Vermont Agency of Transportation
RECEIVED
ON: March 21, 2016
and Checked for
CONFORMANCE
BY: ABC DATE:

DESCRIPTION: FLOORBEAM CAMBER DIAGRAMS

STRUCTURE:	TH-10 OVER OTTER CREEK PONY TRUSS BRIDGE	DRAWN: RB	DATE: 1/9/16
		CHKD: WJL	DATE: 1/11/16
LOCATION:	RUTLAND CITY, VERMONT	JOB NO.	DWG NO.
PROJ NO.	BRF 3000 (19)	598	C1
CUSTOMER:	KUBRICKY CONSTRUCTION CORP.		REV. △

CAMBER DIAGRAM FOR FLOORBEAMS

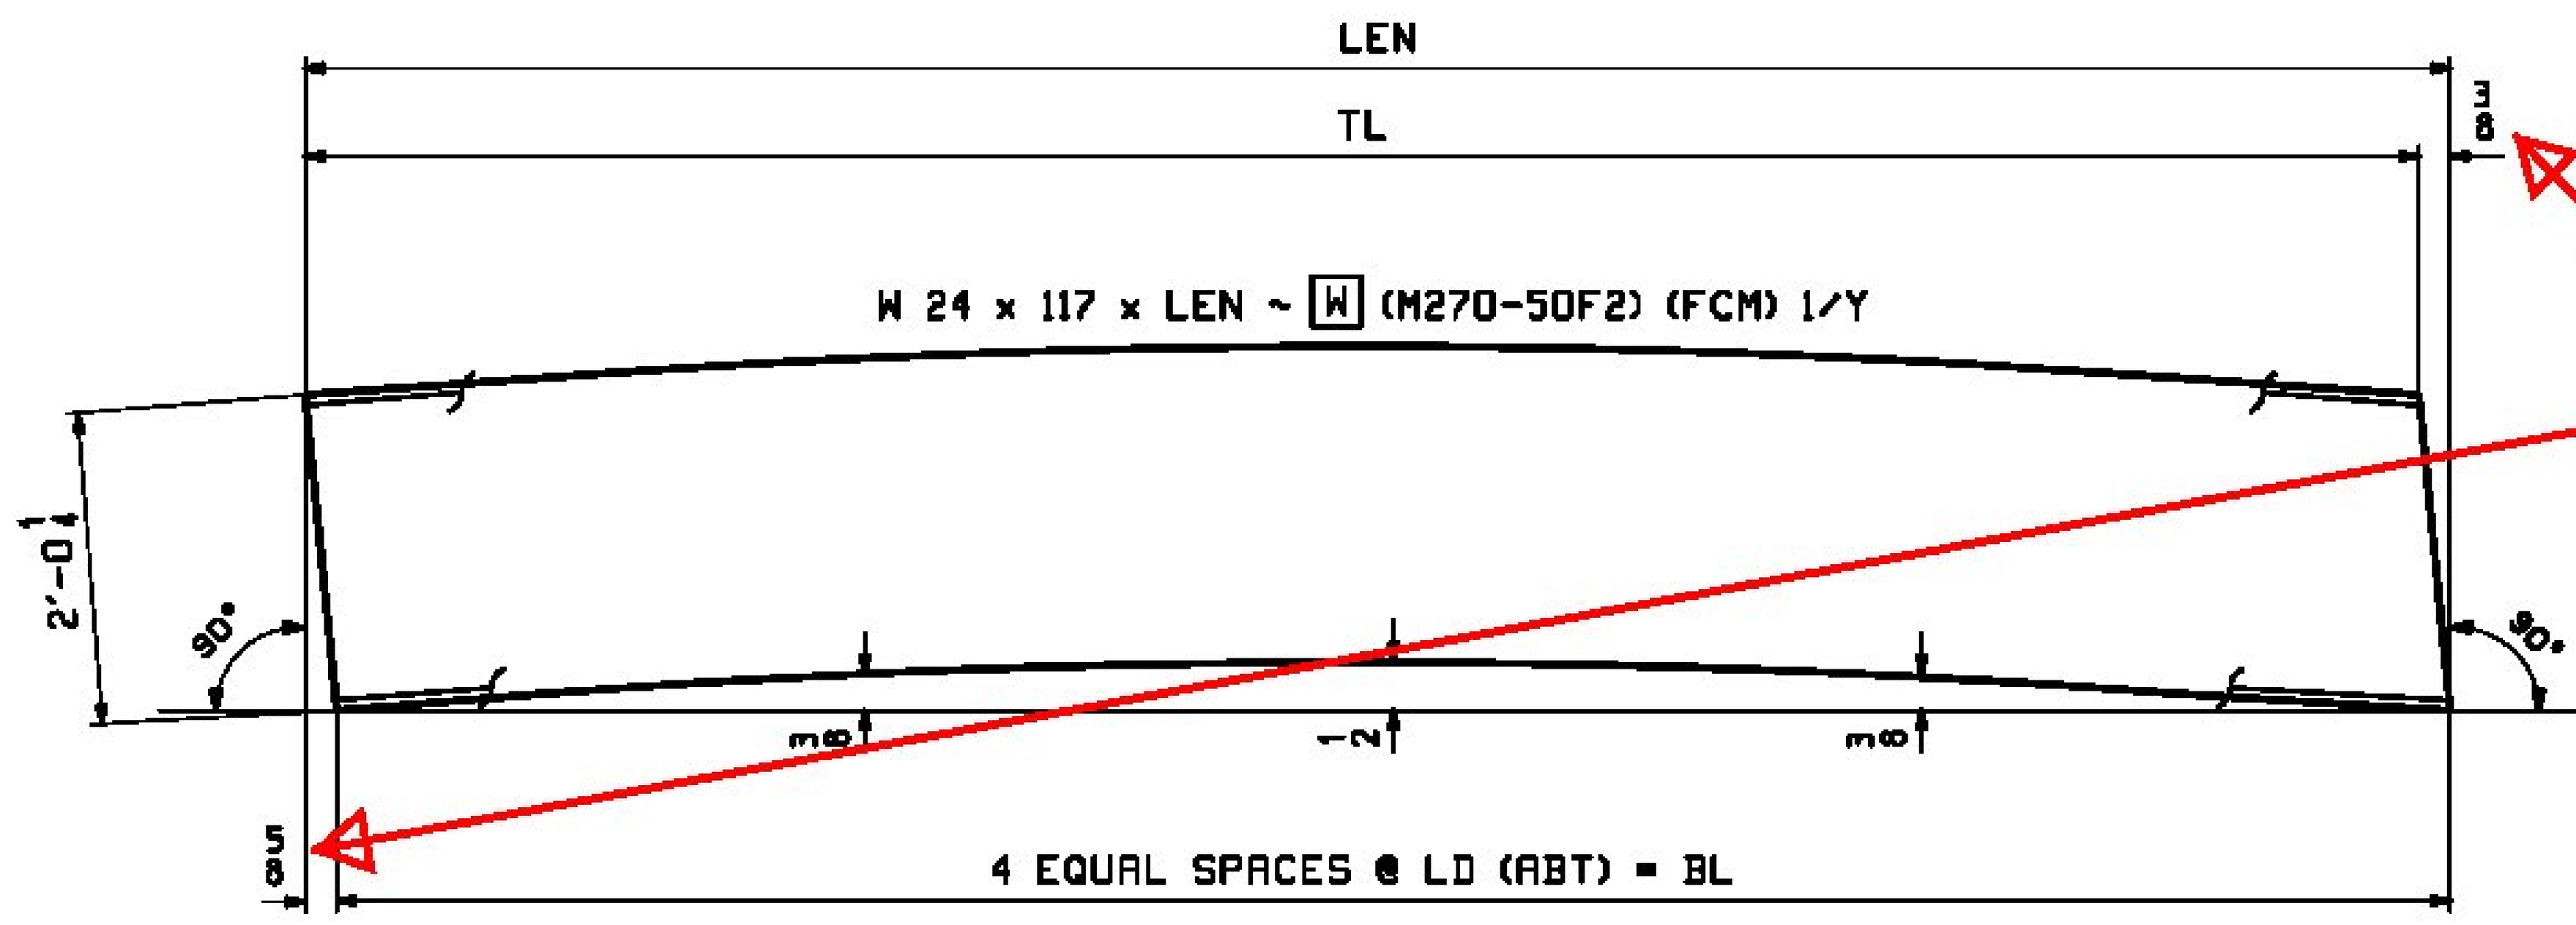
Provide calculations to verify camber deflections and angled ends.
